E C O L O G I C A L R E V I E W

Dedicated Dredging on the Barataria Basin Landbridge
CWPPRA Priority Project List 11
State No. BA-36

August 12, 2004

This document reflects the project design as of the 95% Design Review meeting, incorporates all comments and recommendations received following the meeting, and is current as of August 12, 2004.

Figure 4: Details of earthen containment dike (LDNR 2004).

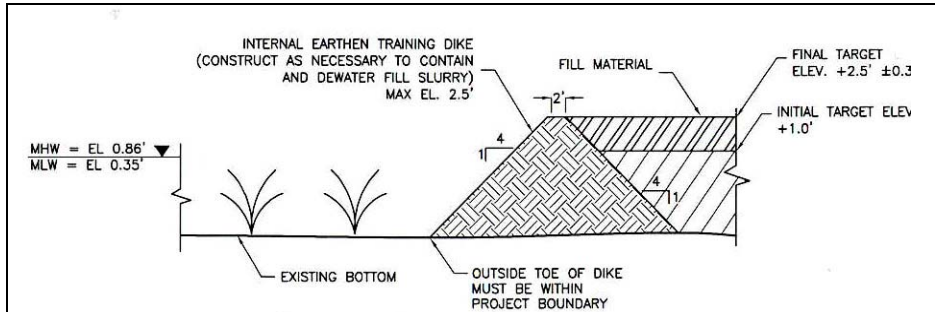
Along the remaining boundary of the project, a total of 28,326 linear feet of earthen containment dikes will be built to an elevation of +4.0 feet NAVD-88 with side slopes of 4(H):1(V) using *in situ* material, to contain the dredged material (Figures 2 and 4). In order to keep the material as consolidated as possible it will be excavated and placed by bucket dredge.

The analysis of 13 soil borings taken in site 1 indicate that the soils are composed of a two foot layer of very soft peat, underlain with eight feet of very soft organic clay and ten feet of very soft clay. The soils in site 2, as indicated by 12 borings taken in the area, are composed of very soft peat to a depth of one foot, underlain by very soft organic clay to a depth of fifteen feet, and very soft clay and silty clay to a depth of thirty-eight feet (Soil Testing Engineers, Inc. 2003). The results of the geotechnical investigation estimate an anticipated levee settlement of 0.8-2.6 feet during the 20 year project life, and established a minimum acceptable safety factor of 1.3-1.5 for slope stability (Soil Testing Engineers, Inc. 2003). The accepted measure of a slope's stability is its safety factor which is the ratio of the forces or moments tending to prevent failure (soil strength, primarily) to those that cause failure (soil and surcharge weights plus seepage forces, primarily). A side slope safety factor of 1.2-2.0 with 1 foot of freeboard, and 0.9-1.5 with 2 feet of freeboard was found for the soil conditions found within the project area. The results of

the geotechnical investigation indicate that the 2 feet of freeboard design has less safety factors than desirable, necessitating the use of reinforcing geotextile with an allowable tensile strength of at least 980 pounds per linear foot (measured perpendicular from the levee centerline) (Soil Testing Engineers, Inc. 2003).

Figure 5: Estimated elevation change of the created marsh over the 20-year project life.

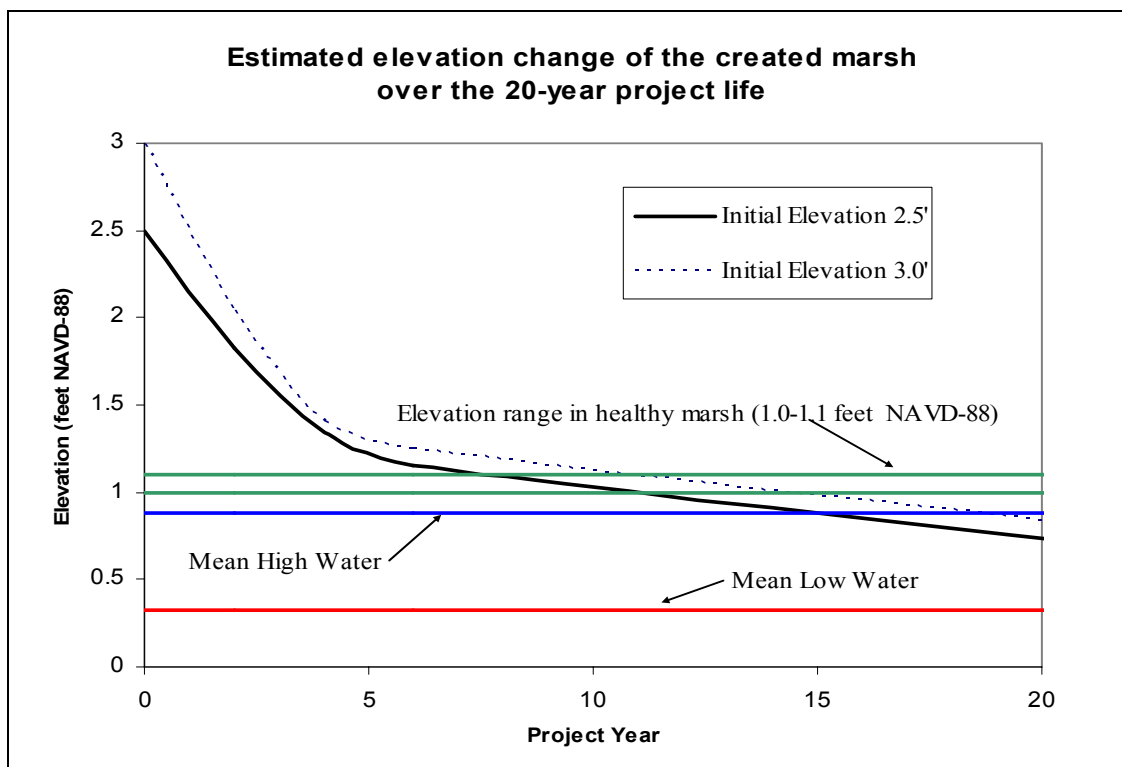
The average elevation range for existing unbroken marsh in the project area is +1.0 to +1.1 feet NAVD-88 (SJB Group, Inc. 2003), though the target elevation for healthy marsh is higher (+1.4 feet NAVD-88) (Kevin Roy, USFWS, Personal Communications, July 7, 2004). Mean low water is +0.35 feet NAVD-88, and mean high water is +0.86 feet NAVD-88. Material dredged from the borrow areas will be used to fill approximately 1,245 acres of open water and broken marsh to an elevation of +2.5 feet NAVD-88. The placement of the dredged material will be accomplished in two lifts to accommodate for initial dewatering. During the first lift the material will be placed at an elevation of +1.0 feet NAVD-88 and allowed to dewater. During the second lift the dredged material will be placed to an elevation of +2.5 feet NAVD-88. The created marsh platforms will initially be above mean marsh elevation. However, this elevation will decrease over time because of subsidence, as well as volume loss brought on by settlement, shrinkage, and dewatering of the dredged material. According to the geotechnical investigation (Soil Testing Engineers, Inc. 2003), it is expected that these factors will lead to the created marsh reaching existing healthy marsh elevations (+1.4 feet NAVD-88) between year 3 and year 4 of the project life (Figure 5). The project design had initially included placement of the dredged material at an elevation of +3.0 feet NAVD-88, however the design was modified because of the higher cost involved and because the results of the geotechnical investigation revealed no significant long term benefit to placing the material at a higher elevation (Figure 5).

In view of the shrinkage, settlement and subsidence rates, the created marsh design initially included placement of the dredged material at an elevation of +3.0 feet NAVD-88. However, the design was modified because of the higher cost involved and because there was no significant long term benefit to placing the material at a higher elevation (Figure 5). As currently designed, and according to the geotechnical investigation (Soil Testing Engineers, Inc. 2003), it is expected that the created marsh will reach healthy marsh elevations (+1.4 feet NAVD-88) between year 3 and year 4 of the project life (Figure 5), and will continue to subside over time. The marsh platform is expected to remain above the intertidal range until approximately year fifteen, and remain intertidal for the remainder of the 20 year project life.
